DFG8340 Installation Diagram Leg Loads: Error Correction Request

There was an error in the installation diagram leg loads indicated in the DFG8340 Installation Manual and Standard Specification Sheet. Please read this document and correct the error.

Applicable document	Part No.
Installation Manual	English: UNWSNEH001A
	Japanese: UNWSNJH001A
Standard Specification Sheet	SSNW10R001 (original version) ~SSNW17R002 (date issued: July 25, 2017)

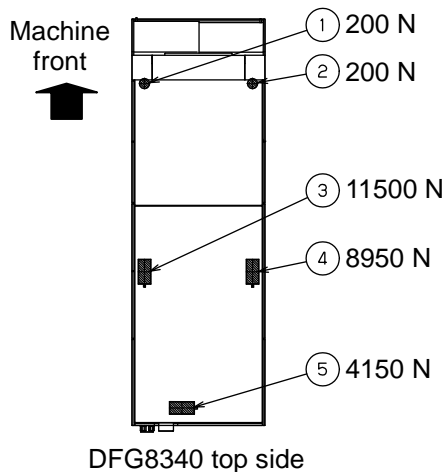
Please correct the leg loads as shown in the diagram below.

No. in diagram	Load (before correction)	Load (after correction)
1	200 N	200 N (no correction)
2	200 N	200 N (no correction)
3	1150 N (error)	11500 N
4	895 N (error)	8950 N
5	415 N (error)	4150 N
